P 544445-B

**ON-SITE SEWAGE DISPOSAL SYSTEM
 HOWARD COUNTY HEALTH DEPARTMENT
 BUREAU OF ENVIRONMENTAL HEALTH**

SUBDIVISION: The Warfields II LOT NUMBER: 41

ADDRESS: 14858 Michele Dr. PROPERTY OWNER: _____

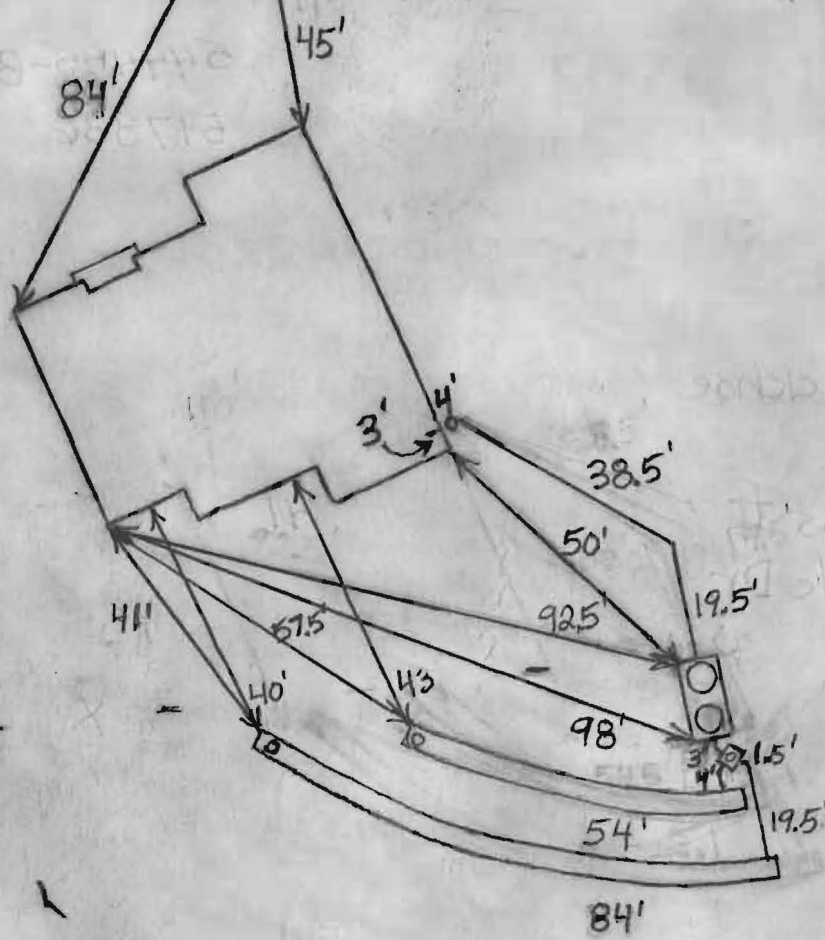
12/21/2012 I install a 55' and 85' trench on contour towards the house in the highest part of the septic easement. O.K. to put the tank in the easement uphill of the trenches. (BB)

1/2/2013 Tank set (BB)
 1/3/2013 Need house connection. (BB)
 1/4/2012 AM + PM

1/7/2013 Levelers installed. Still need house connection. (BB)
 2/7/2013 House connection made. (BB)
